NUREG-0528
Supplement No. 1

Safety Evaluation Report

related to the operation of
Wm. H. Zimmer Nuclear Power Station,
Unit No. 1

Docket No. 50-358

FIGURE I.B.1.2-1

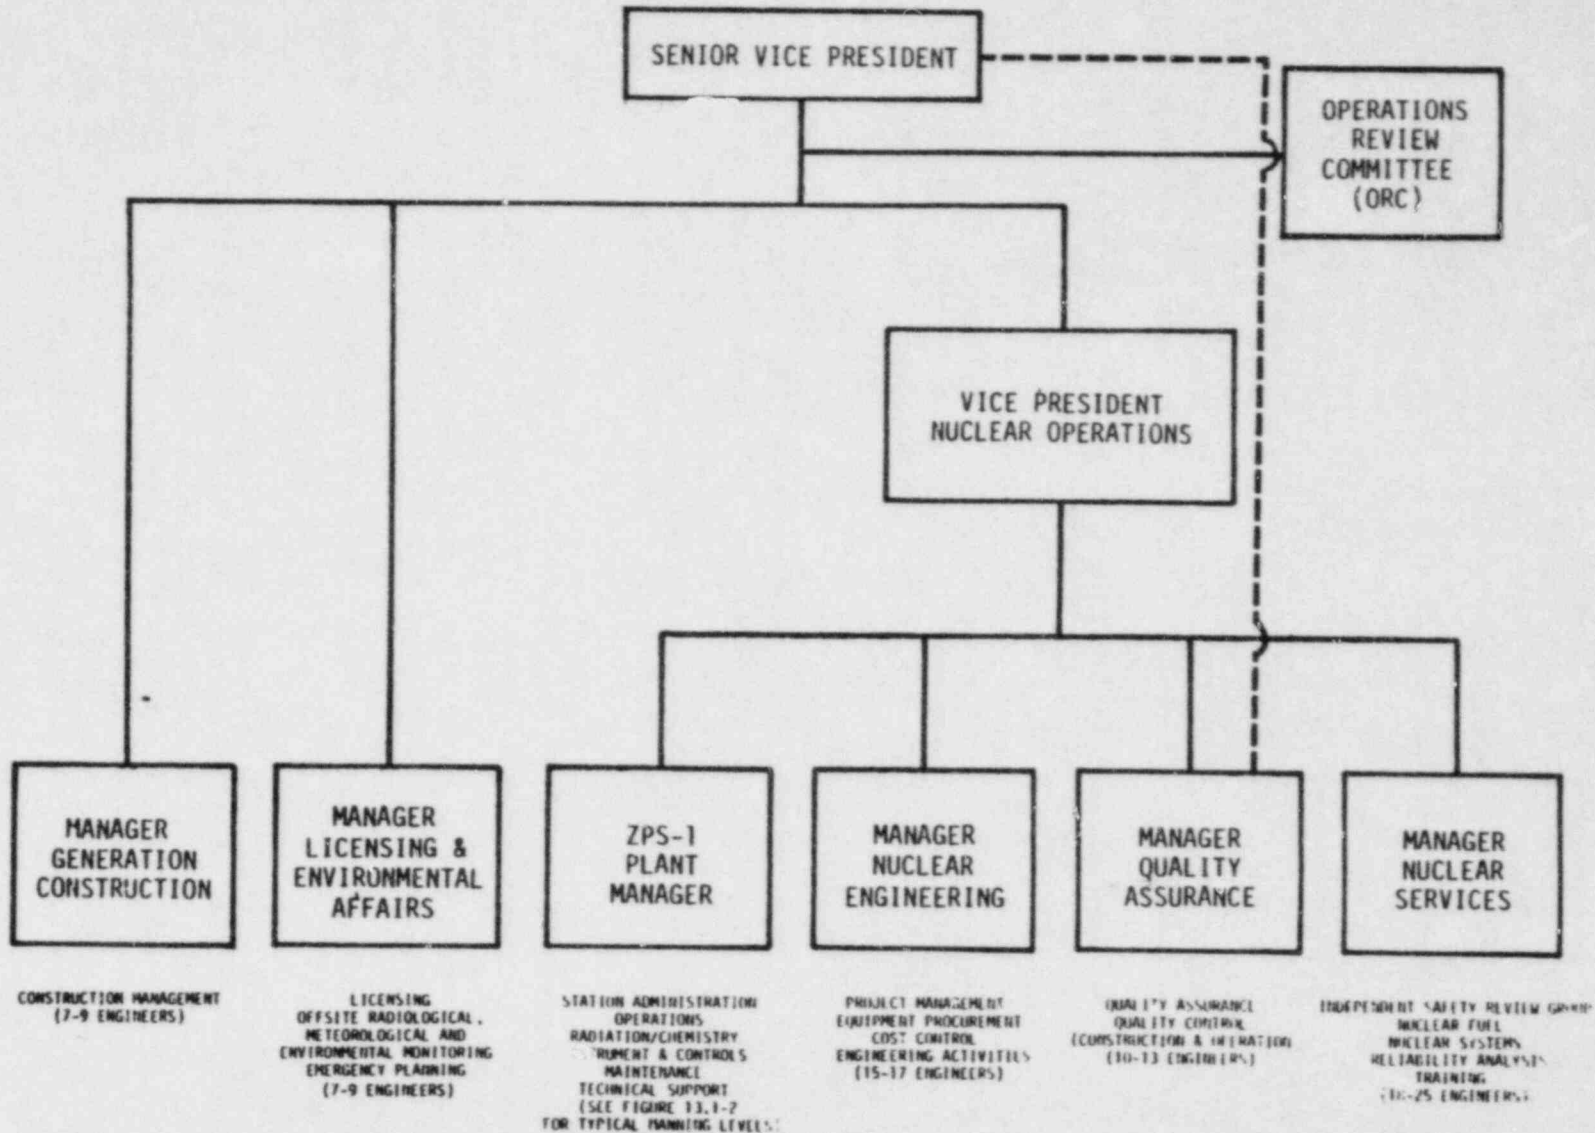
Under the new organization the Zimmer Station Superintendent has been redesignated as the Manager, W. H. Zimmer Station. The organization at the site reporting to this Manager remains essentially as it was before except that the onsite quality assurance staff and the training coordinator who previously reported to the Station Superintendent will now report offsite to the new Manager, Quality Assurance and the new Manager, Nuclear Services, respectively.
